PCN – Process Change Notification

Change:	OMB.6912.03F21
Date:	2016/07/12
Author	Kim Ho

Model#	Part Number	Changes
698~960MHz and 1710~2170MHz 2-3.5dBi Omni Antenna with N Type Female ,U Bolt	OMB.6912.03F21	Amend Aluminium tube brackets.

Old drawing

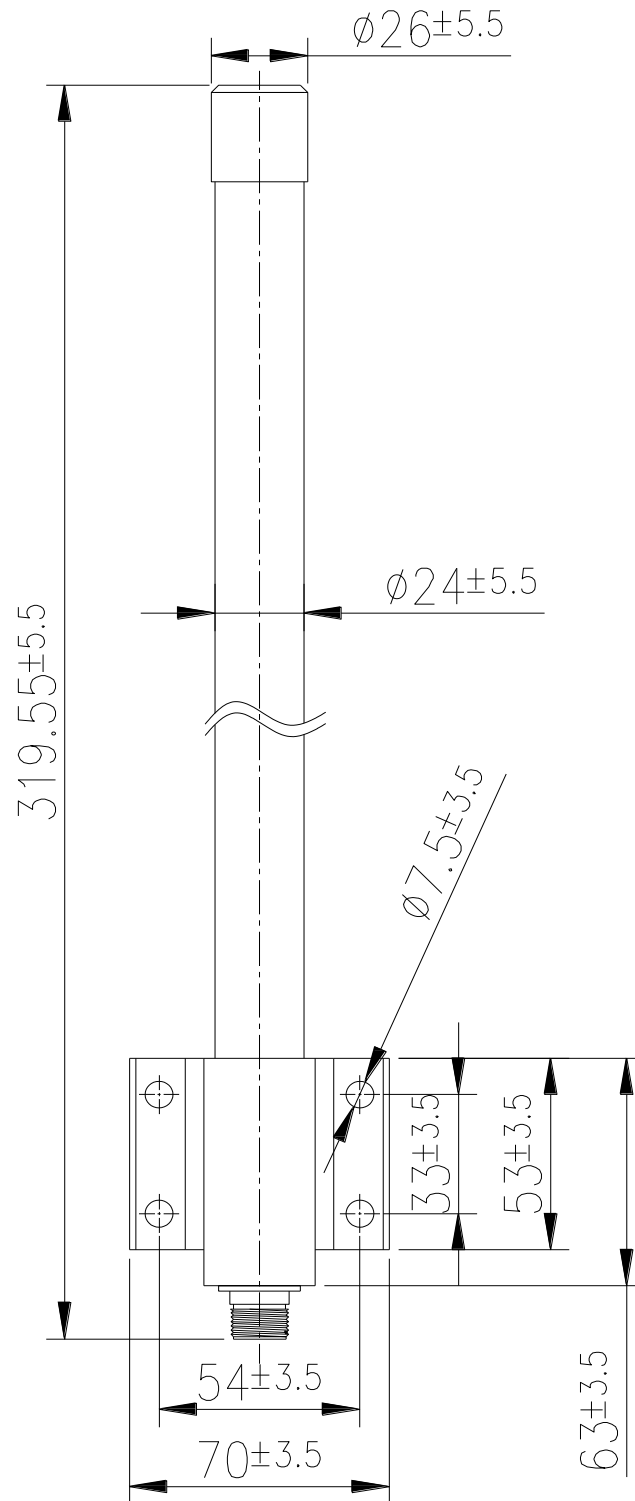
- Due to antenna performance, Aluminium tube brackets size need to amend from 63mm to 45mm, also change four mounting holes to two mounting holes.
